Certificate of Appropriateness

2525 N. SHERMAN BL. Washington High School Sherman Boulevard Historic District

PTS ID 114210 COA Reduce chimney height

Historic view of west elevation with power plant and chimney

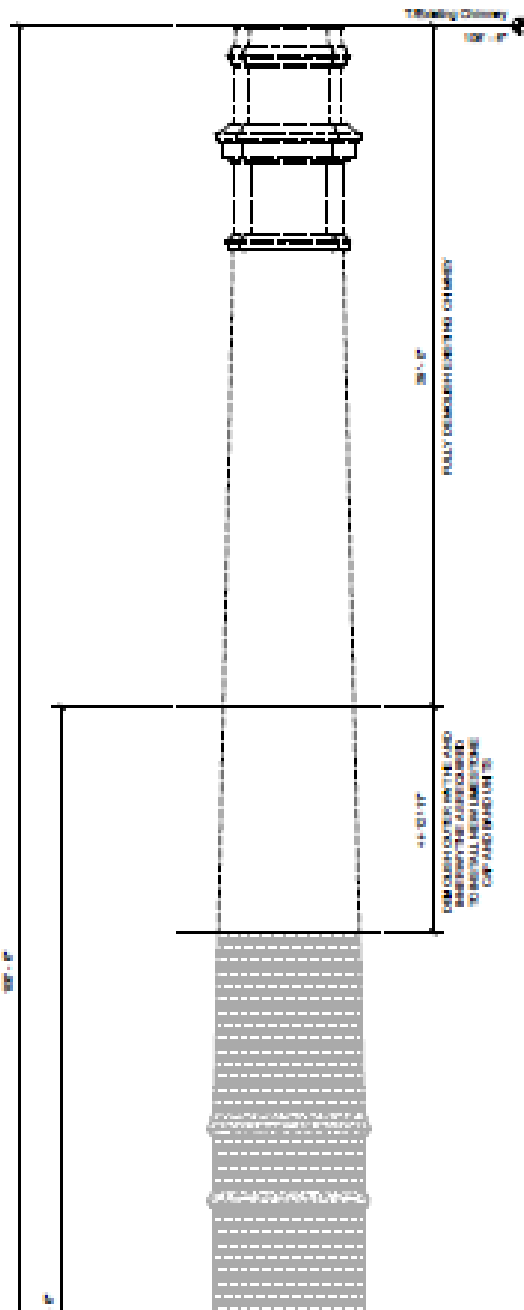
The top 36 feet of the chimney will be removed, an additional 12 feet of masonry will be removed and rebuilt to recreate the ornamental features of the current/original chimney top. Stone will be salvage where possible and new stone will be cut to match where needed.

These details will be recreated at the new chimney top. The new chimney height (71 feet) will extend one-foot above the parapet wall of the school. Stone will be salvaged where possible. Mortar samples and any new stone must be approved by staff before work begins.

The rebuilt portion of the chimney must match the original in color and size of brick and in color, size and type of stone. Mortar will match the original in terms of color, texture, strength, and finish.

New stone samples must be reviewed by Historic Preservation staff before purchase and installation. Mortar samples are to be reviewed by staff before work can begin.
